ADDENDUM

JLG 16098 Bottineau Ridge II Apts

Issued: December 07, 2017

ADDENDUM #: 01

SF03

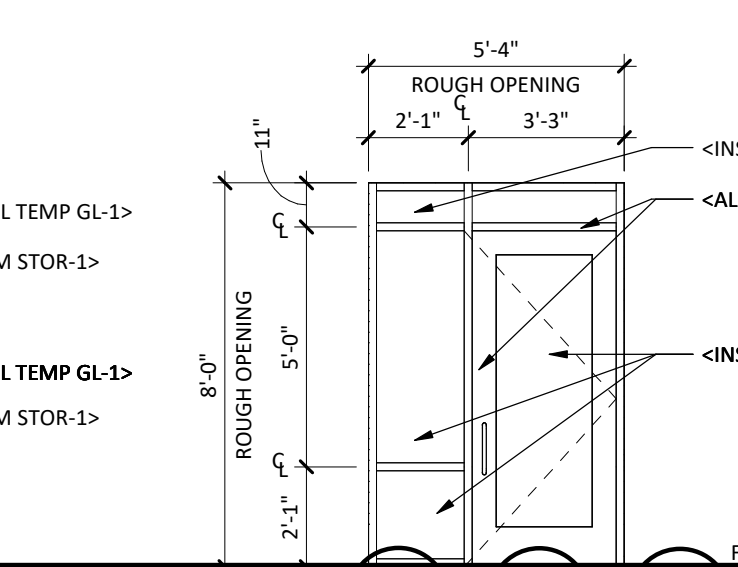
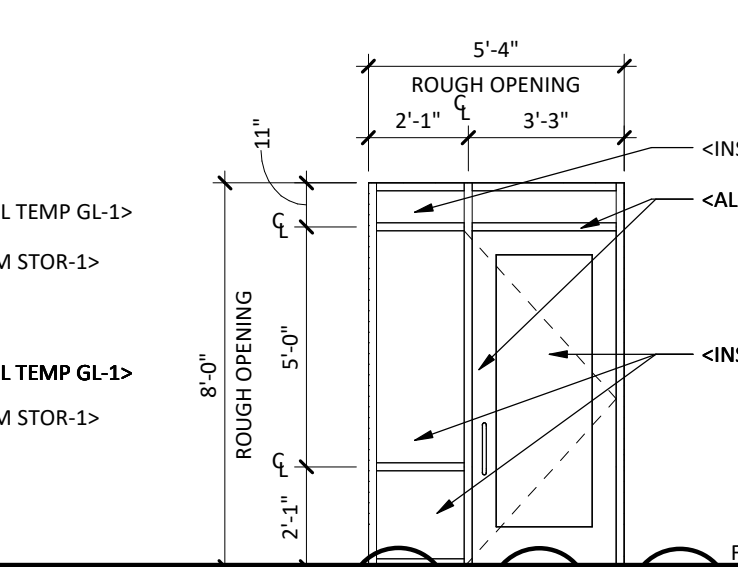
- Storefront Frame Types. Frame Type SF03 add note "@ Lobby-102B Glazing is <TEMP GL-1>".
- Door Types. Revised Door Type "E". Added applied trim to the Hallway side of the door.
